Spire STL Pipeline Project

October Supplement

FERC Docket Nos. CP17-40-000 and CP17-40-001

October 2017

SCALE: 1"=100'
STLP-SS-003

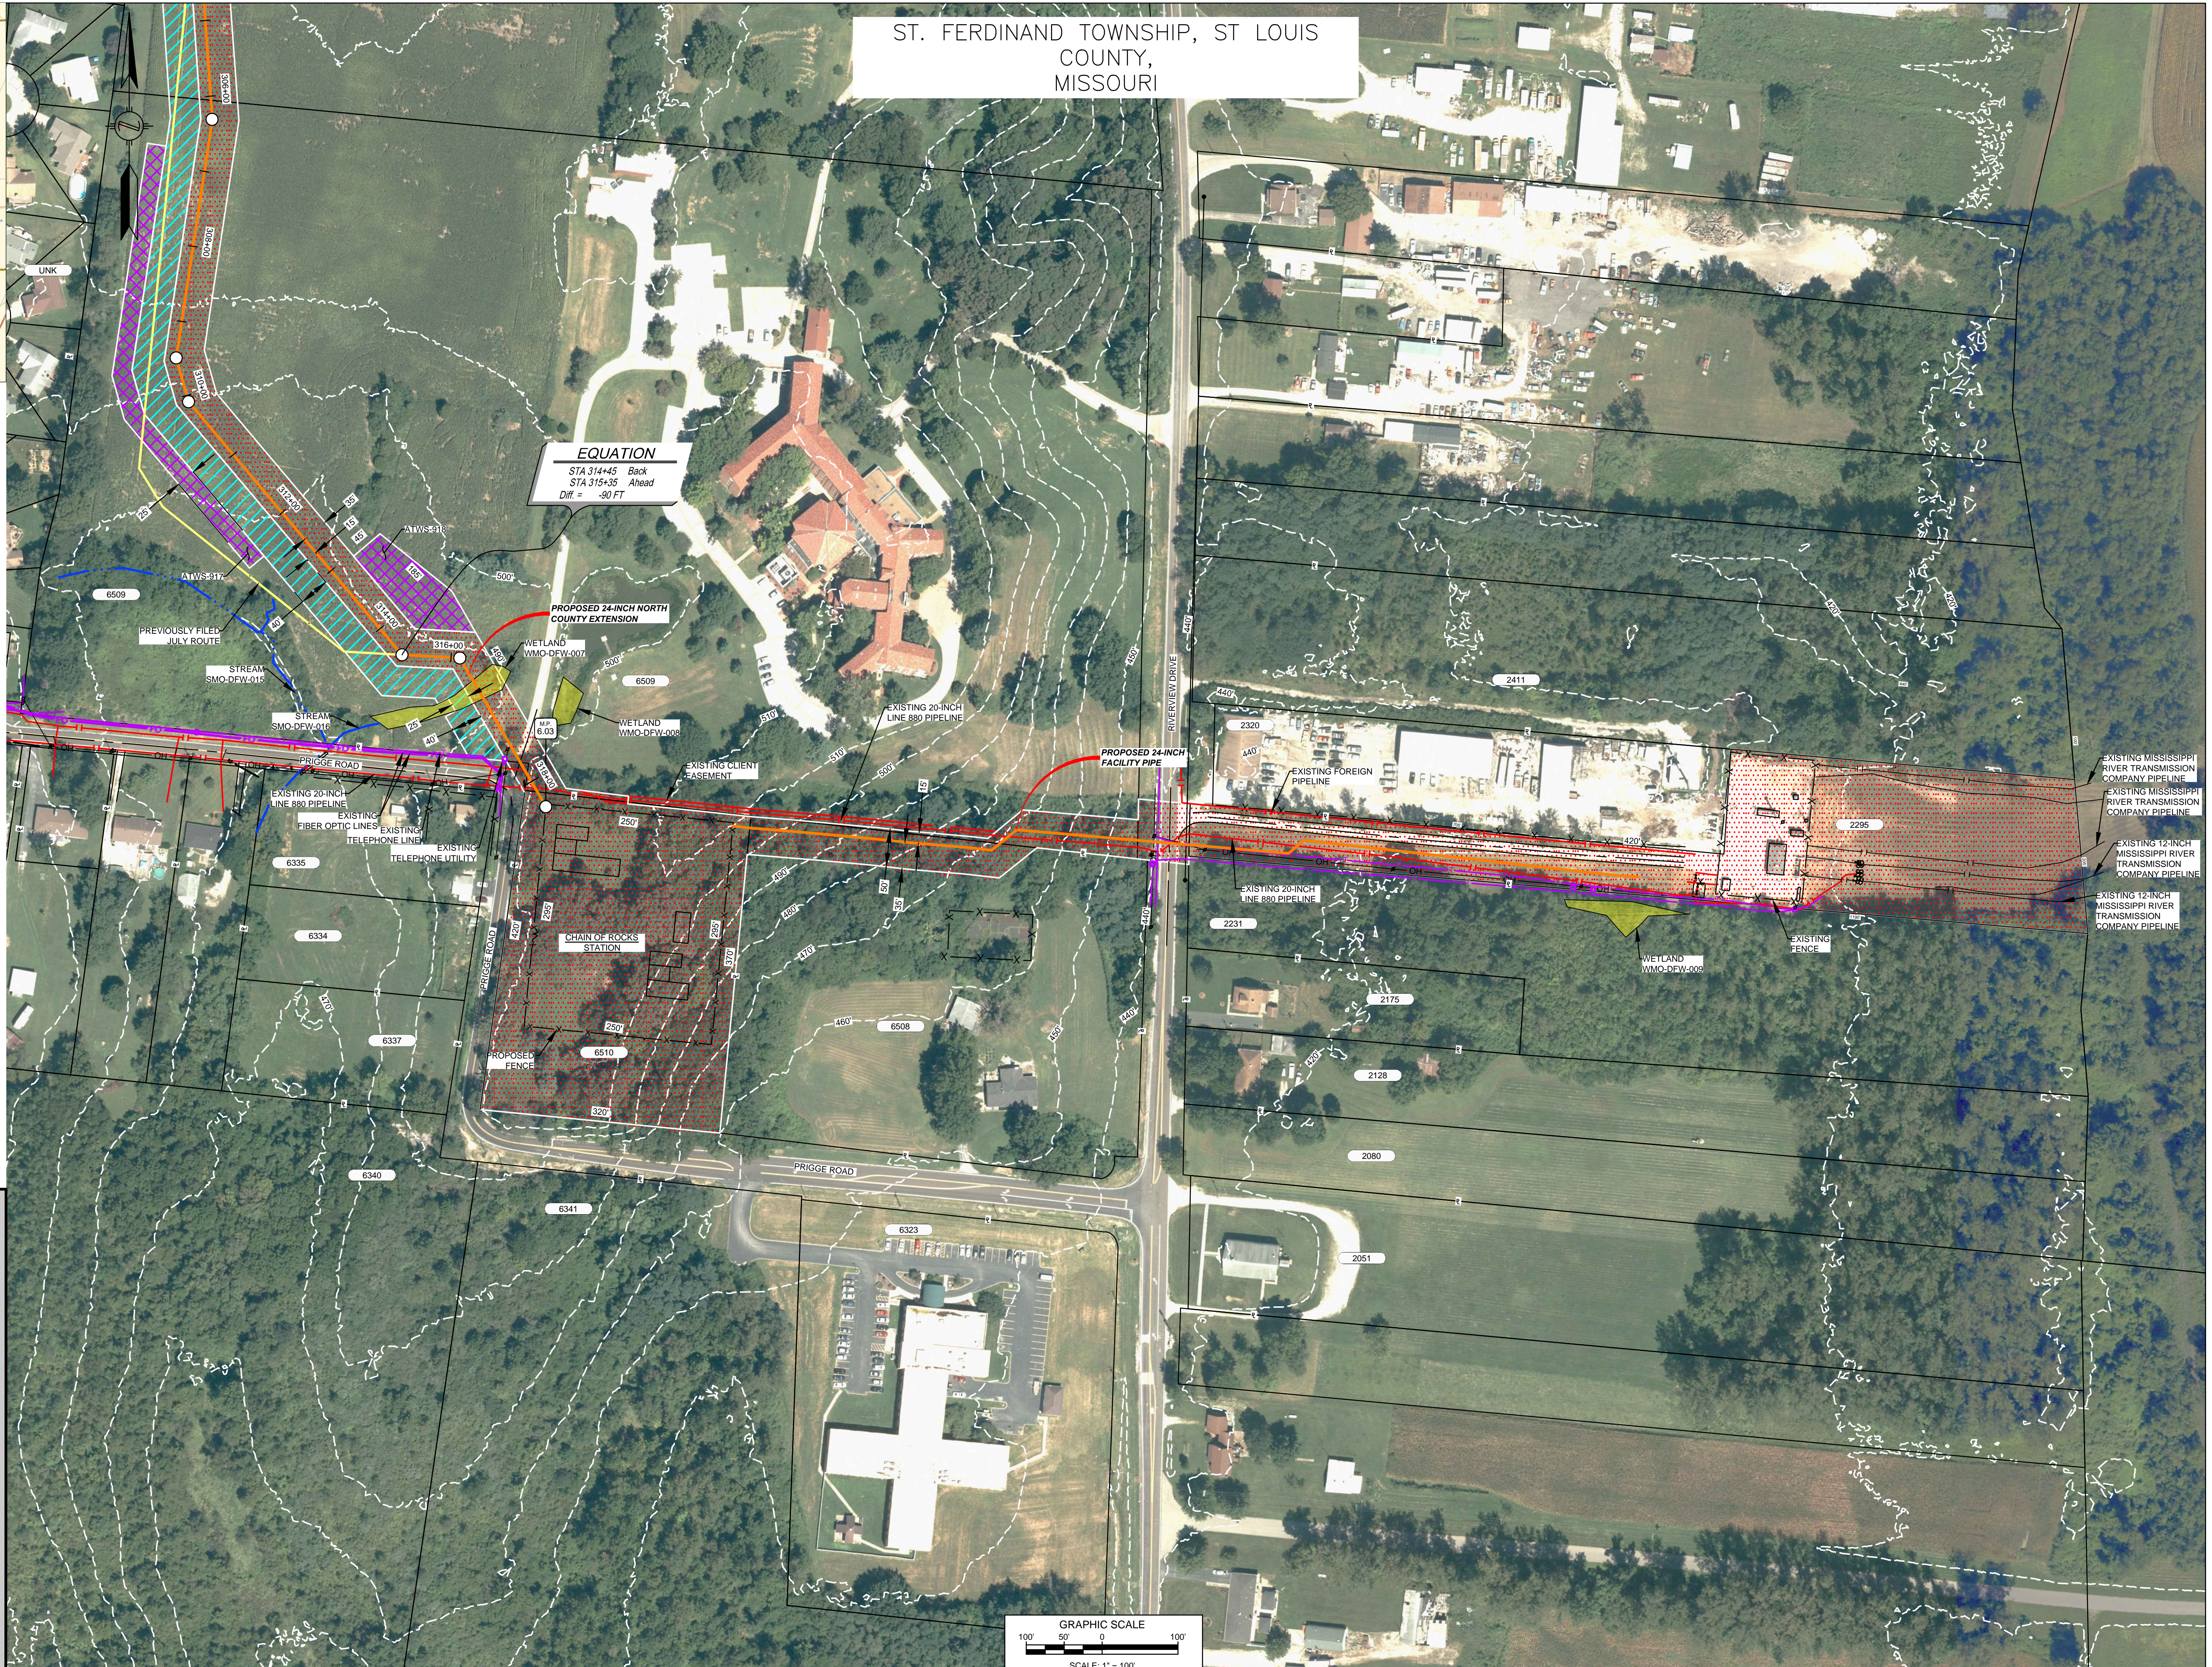
5.8-6.0	Route modification/ Workspace modification	Adjusted for constructability and adjust associated workspace	STLP-A-1007, STLP-SS-003	Avoids two stream impacts [SMO-DFW-015 (perennial), SMO-JJP-007 (intermittent)]
Aboveground Facilities				
Laclede/Lange Delivery Station	Increase in permanent easement from 4 to 5 acres	Spire will be purchasing 5' acres in fee ⁴	STLP-A-068	No additional environmental concerns
Laclede/Lange Delivery Station	ATWS was added on the eastern boundary of the Site	This will provide the necessary workspace to perform work on an existing valve near the property line	STLP-A-068	No additional environmental concerns

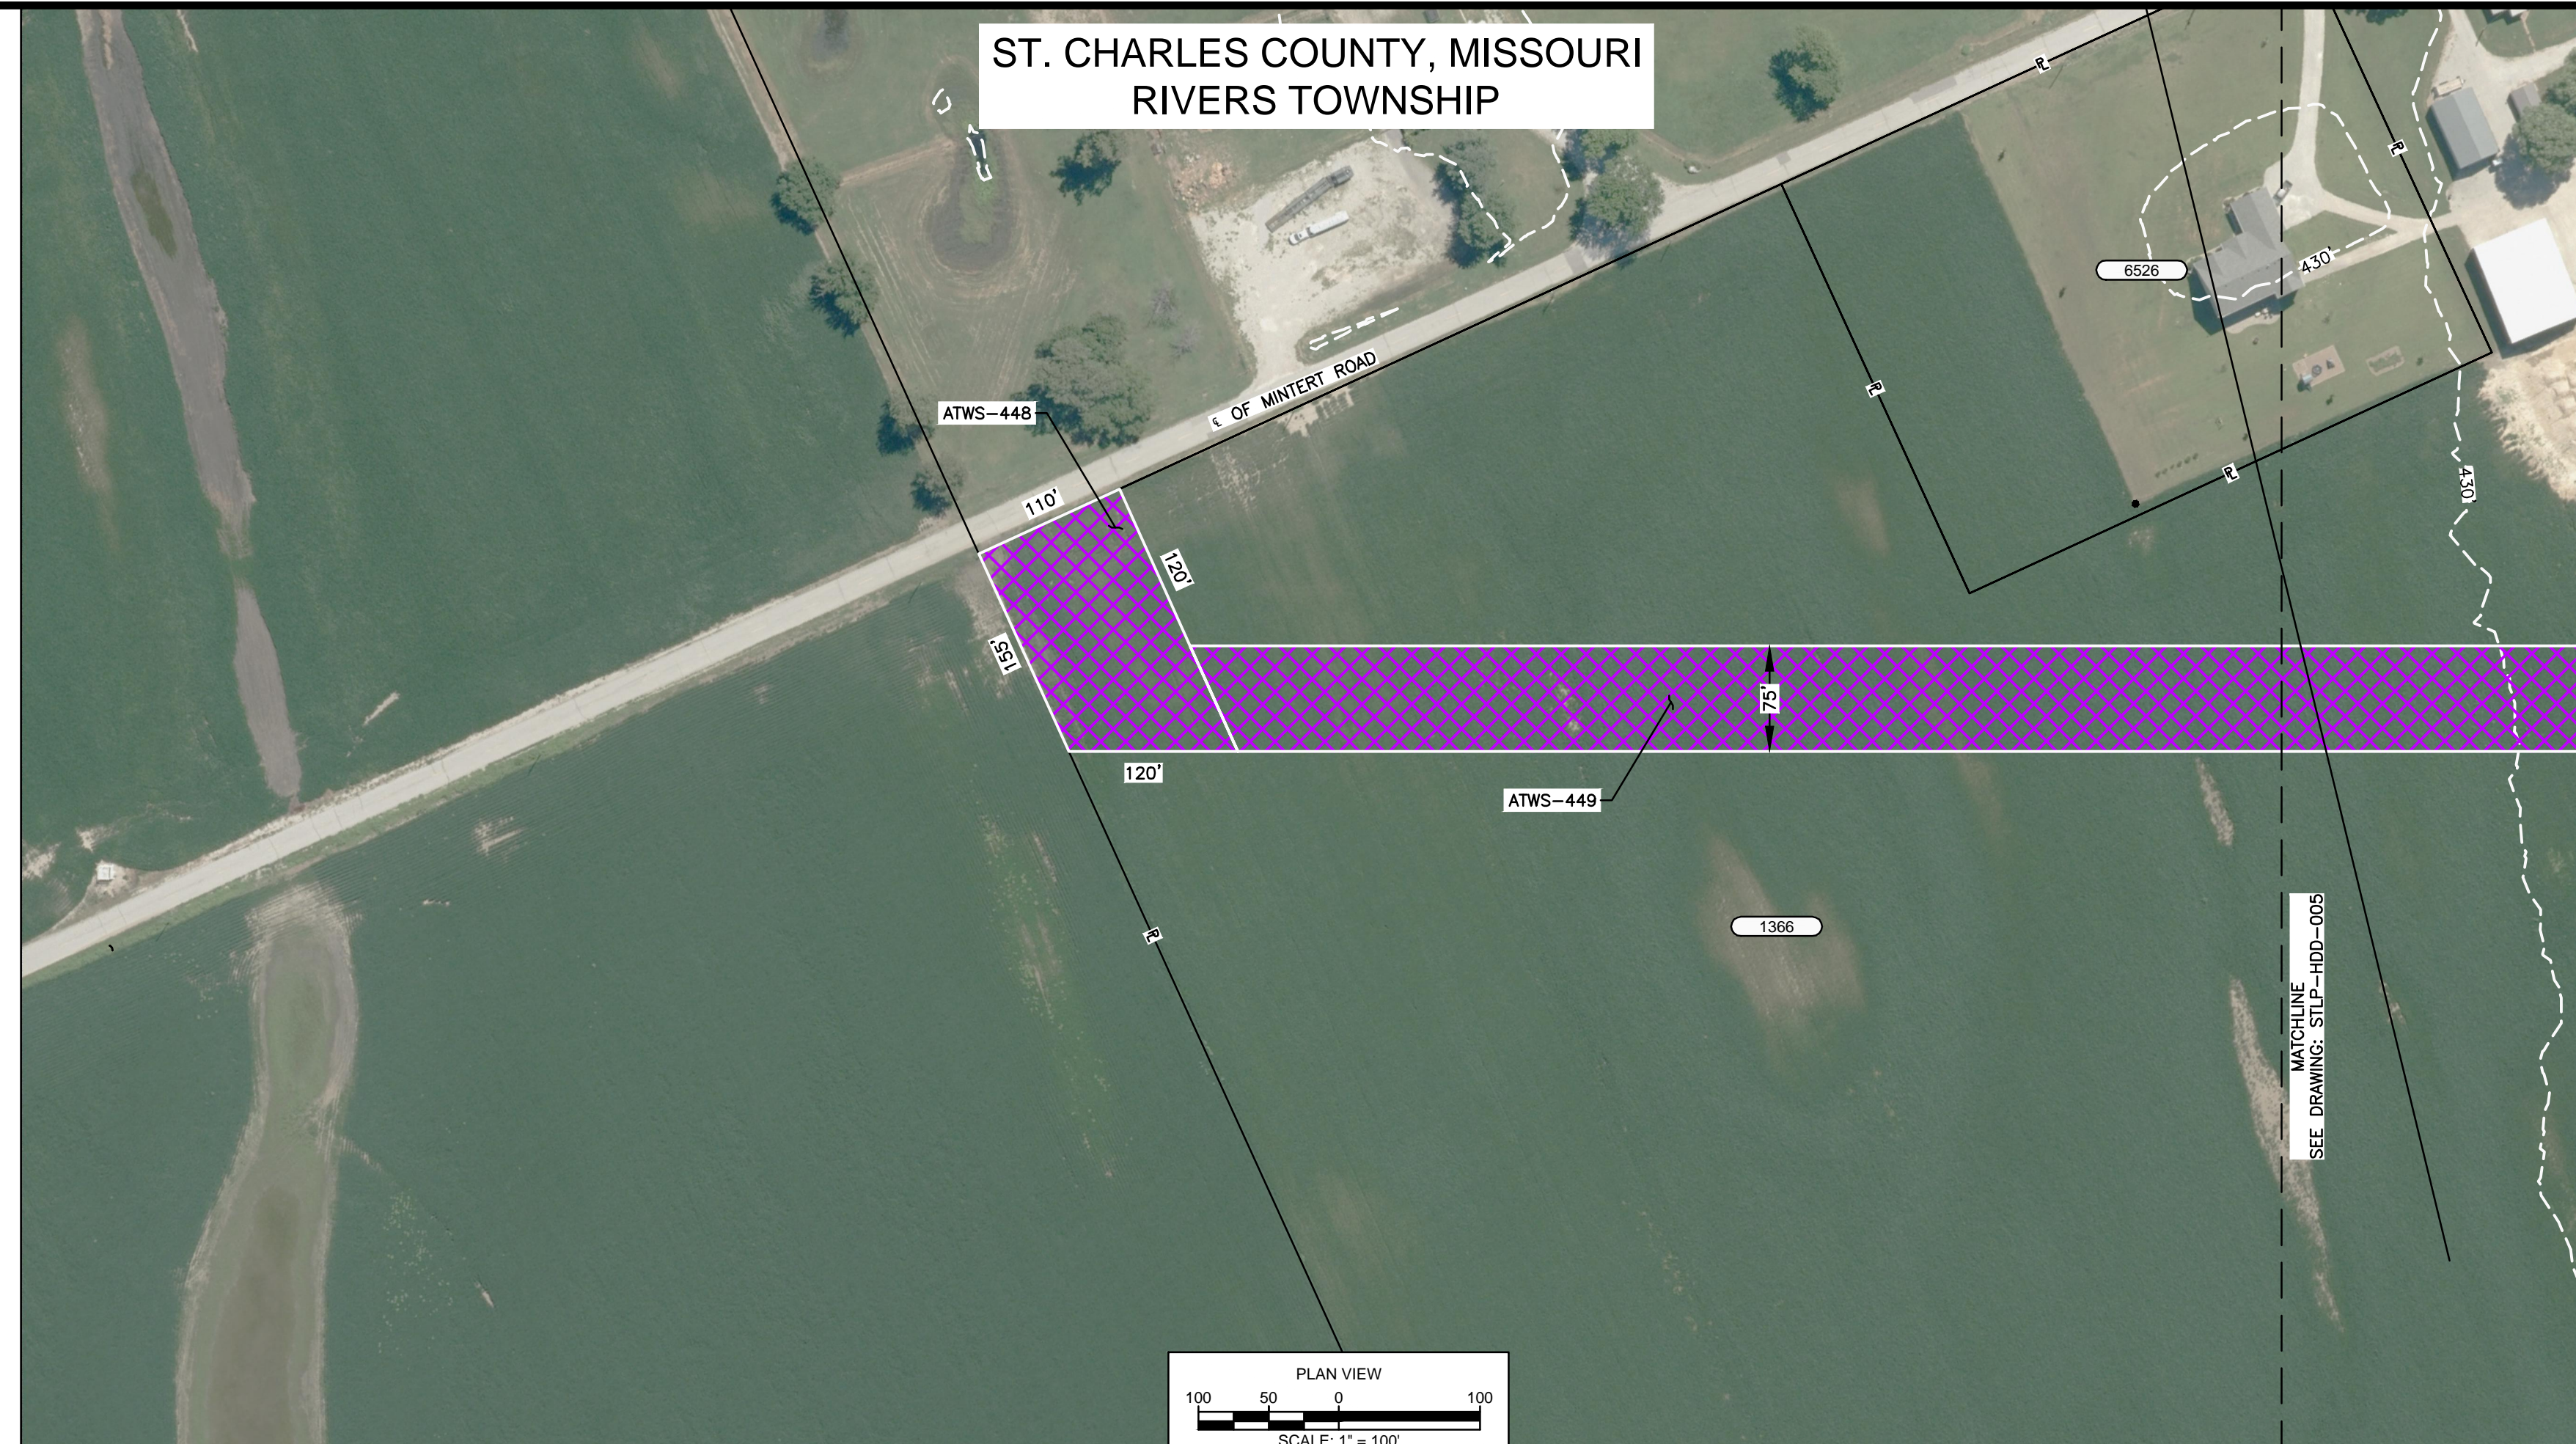
Milepost(s)	Description of Change	Justification ^{1, 2, 3}	Drawing Number	Environmental Impacts
24-Inch Pipeline (Continued)				
56.9	Workspace modification	HDD pullback workspace modified based off of parcel rectification	STLP-HDD-005A	No additional environmental concerns

SPIRE STL PIPELINE PROJECT
 HDD PROFILE OVERVIEW
 SPANISH LAKE PARK NORTH COUNTY EXTENSION
 SPANISH LAKE TOWNSHIPS, ST. LOUIS, MISSOURI

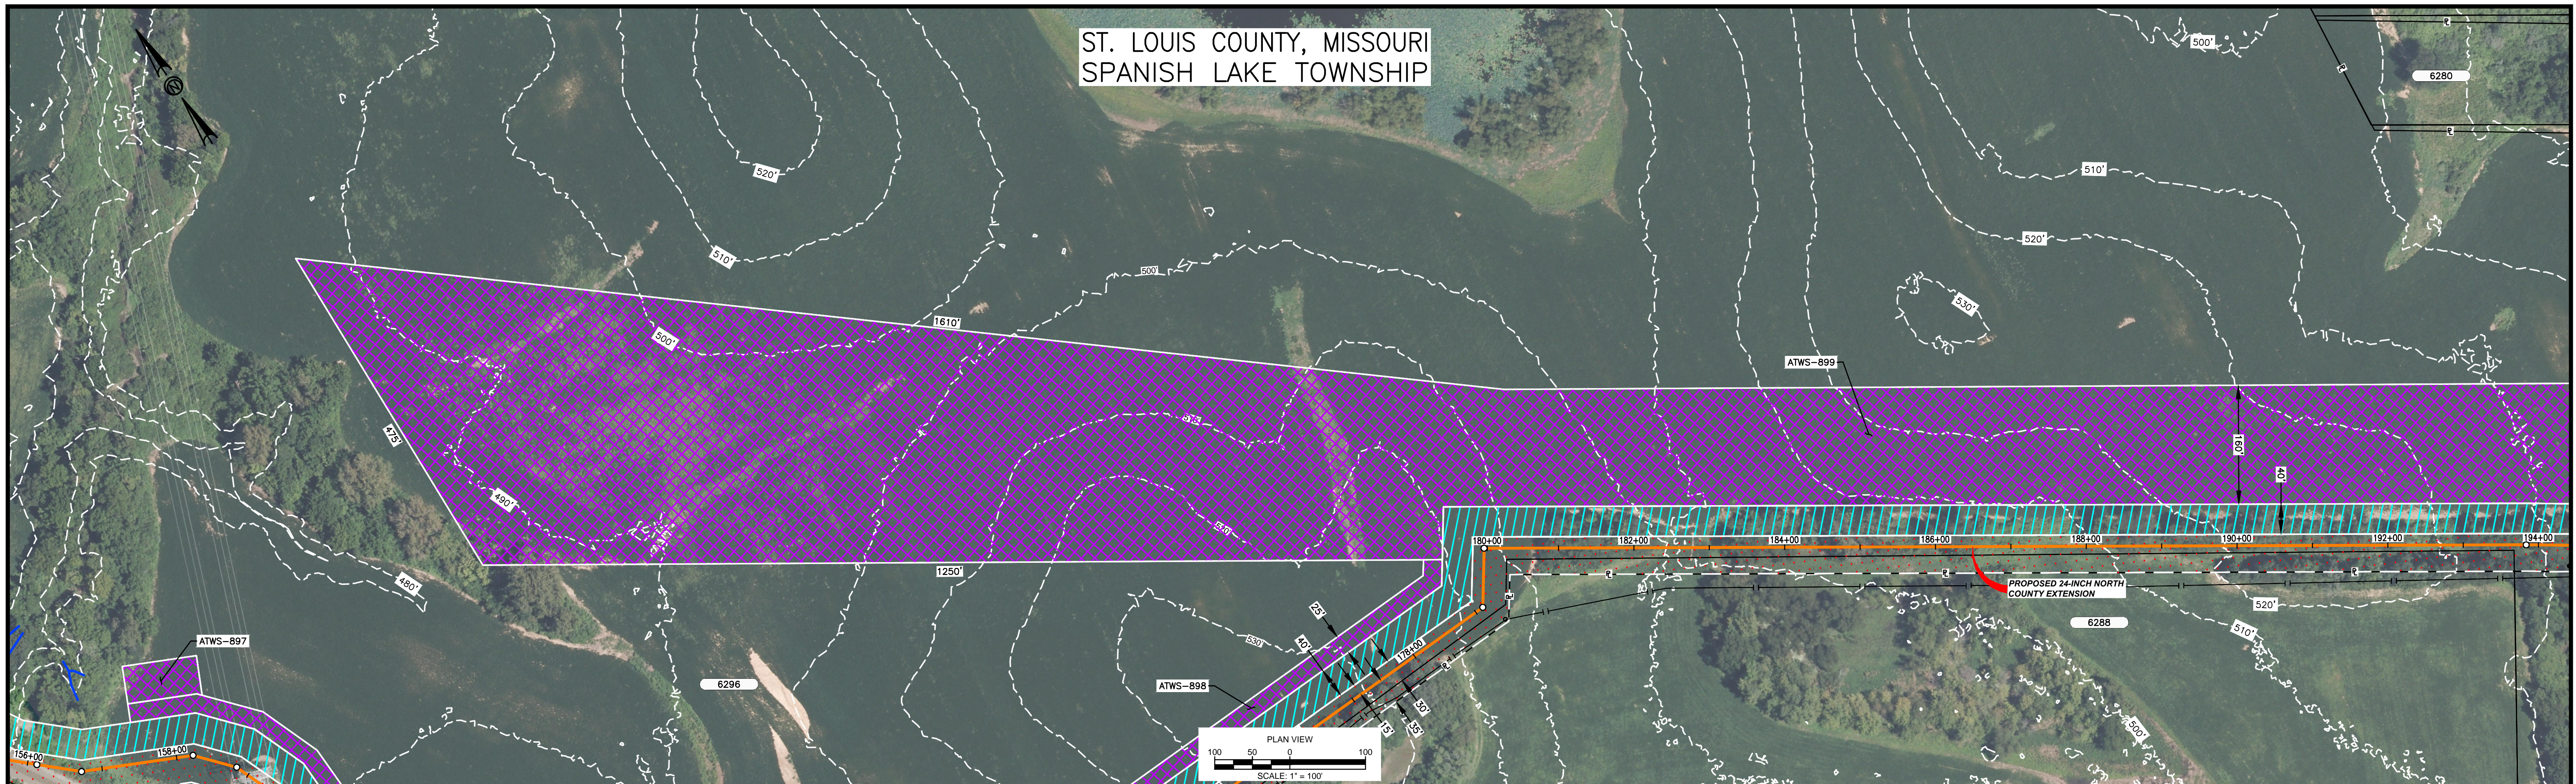
2.3-3.8	Workspace modification	Workspace was modified per updated survey information	STLP-A-1003, STLP-HDD-1003	Slight net increase in wetland impact [reduction at WMO-JJP-119 (PEM), increase at WMO-DFW-002 (PEM)]. Avoids two stream impacts [SMO-TMA-019 (ephemeral), SMO-TMA-018 (ephemeral)]. Less than three-quarter acre increase in forest impact.
